**SITE PLAN REVIEW SHEET
ENVIRONMENTAL VARIANCE REQUEST ONLY**

CASE: SP-2021-0091C

PROJECT NAME: Oltorf Site Plan

ADDRESS OF SITE: 4544 E Oltorf Street

CUT/FILL EXHIBIT

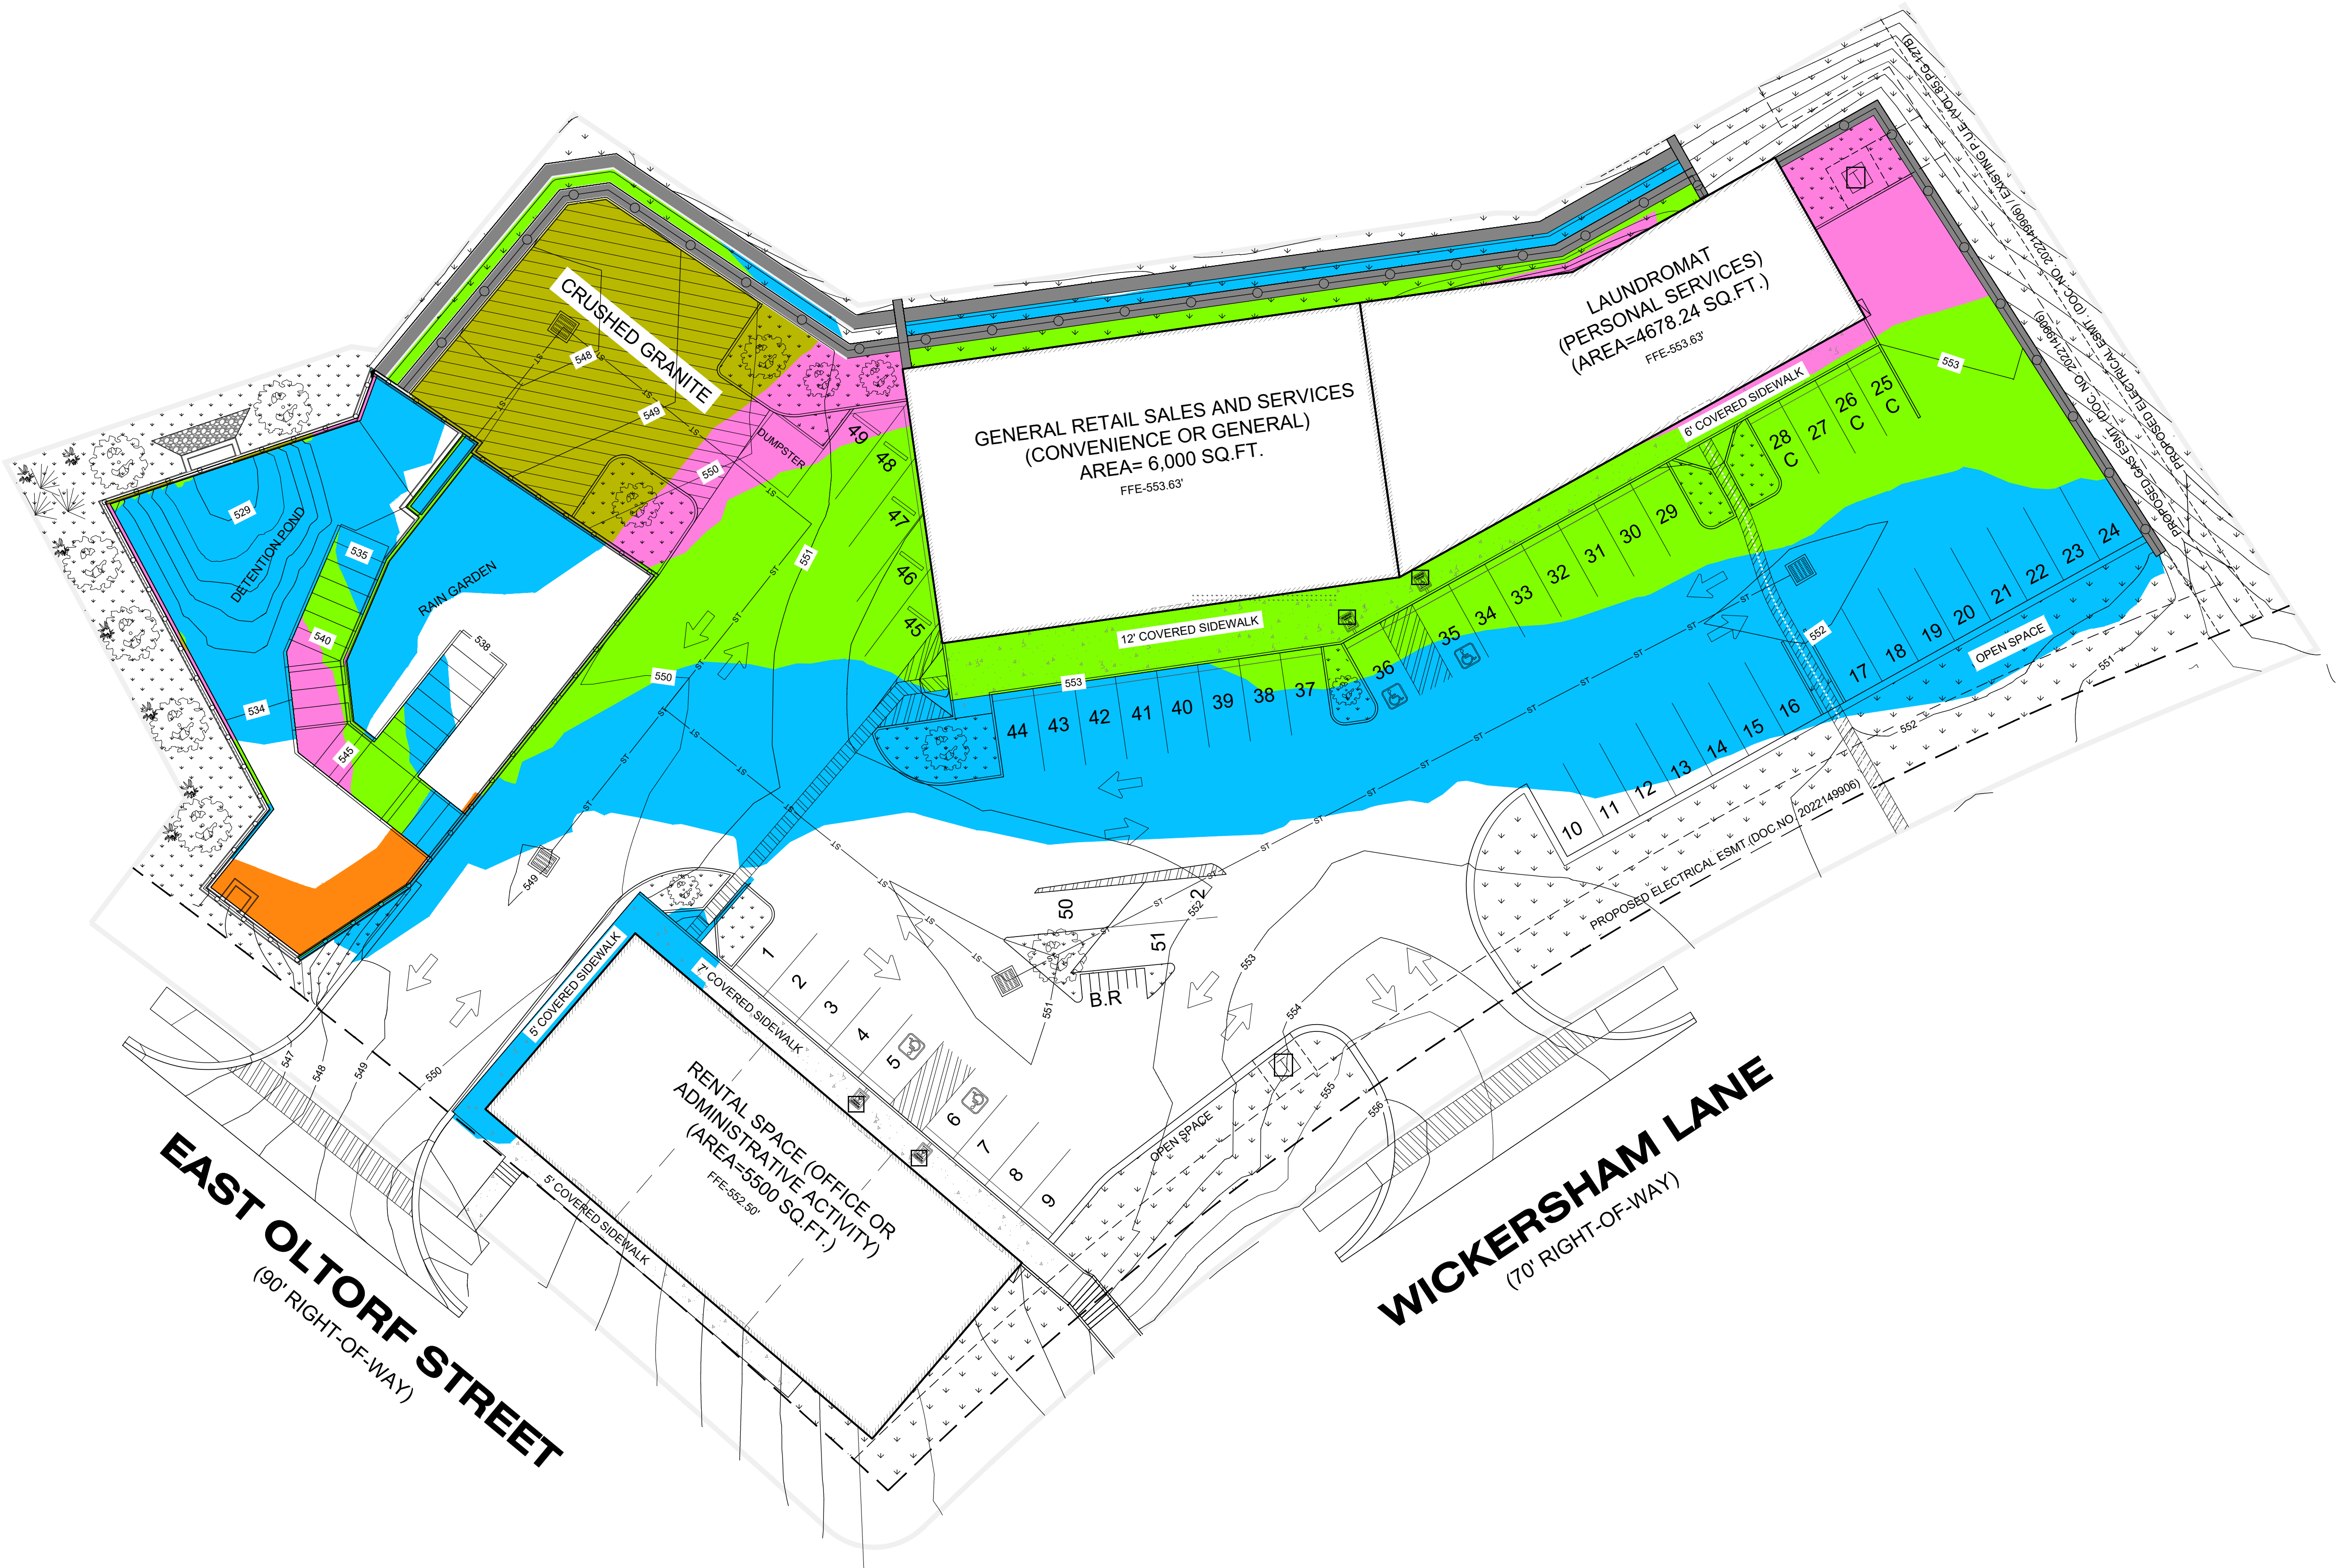
In order to facilitate this type of drainage which will require stormwater releases from detention ponds to flow into the storm sewer pipes along east Oltorf, grading within the detention/water quality area will have cut up to 8 feet and fill up to 20.5 feet.

- Provide 8 additional trees at 3 caliper inches.
- Provide structural containment of fill with retaining walls.
